### Office Action Summary

10/779,471

BARUH, BRADFORD G.

**DETAILED ACTION**

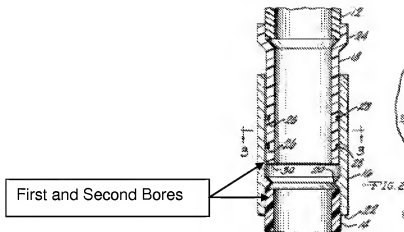
In regards to claim 1, Williams discloses a pipe coupling (16) comprising: an elongated housing having a first end and a second end, the housing defining an elongated bore therein; a stop (20) located on an inner diameter of the housing, the stop located between the first end and the second ends of the housing, wherein a distance from the stop to one of the first and second ends is at least two times a distance from the stop to the other of the first and second end of the housing; a first cylindrical bore extending from the first end to the stop; and a second cylindrical bore extending from the second end to the stop, and wherein each of the cylindrical bores are configured to allow a pipe end to advance into the pipe coupling until reaching the stop.

Williams does not disclose an angle between the first cylindrical bore and the second cylindrical bore is about 15 degrees to about 165 degrees. Waterhouse teaches couplings (1, 5, 6, 9, 13, 14) with an angle between a first cylindrical bore and a second cylindrical bore being about 15 degrees to about 165 degrees, to employ different angles for conventional plumbing (col. 1, lines 45-57). As Waterhouse relates to geometrical structures using plumbing joints, it would have been obvious to one having ordinary skill in the art at the time the invention was made to fabricate couplings with an angle between a first cylindrical bore and a second cylindrical bore being about 15 degrees to about 165 degrees, to employ different angles for conventional plumbing, as taught by Waterhouse.

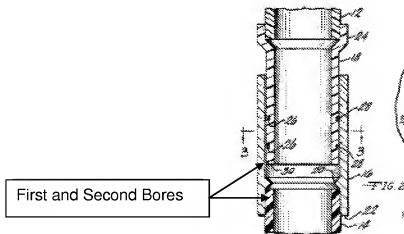
In regards to claim 29, Williams discloses the stop being a single stop located on the inner diameter of the housing.

In regards to claim 30, Williams discloses the stop being a single stop located on the inner diameter of the housing.
